Access Compliance Report

Public Rights-of-Way

Intersection ID: N/A	Main Street: SPEER_BV	Cross Street: NATIONAL_AV	Location: NE
ADA ID: E9BA7A054B43	Ramp Type: Directional1	Initial Pass/Fail: Pass	Overall Compliance: No
Severity Score: 5.25			
Codes/Mitigation Info/Possible Solution		Field Measurements/Component Compliance

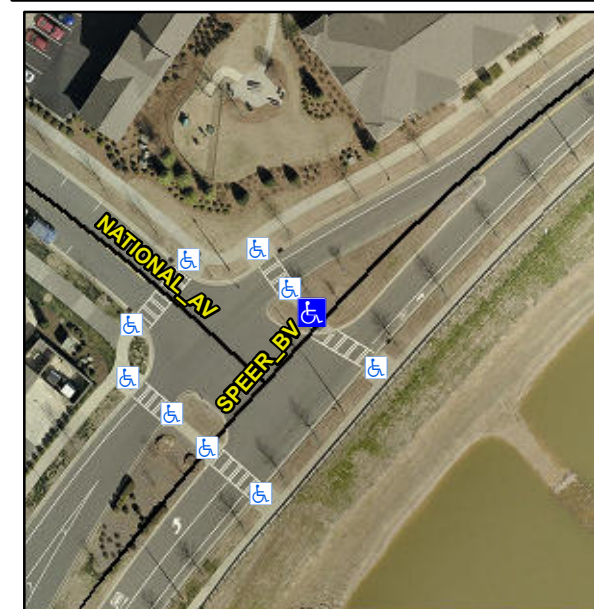
LOCATED ON MEDIAN

R304.5.3, R304.5.4

**Remove & Replace Entire Ramp.
Remove & Replace Gutter.**
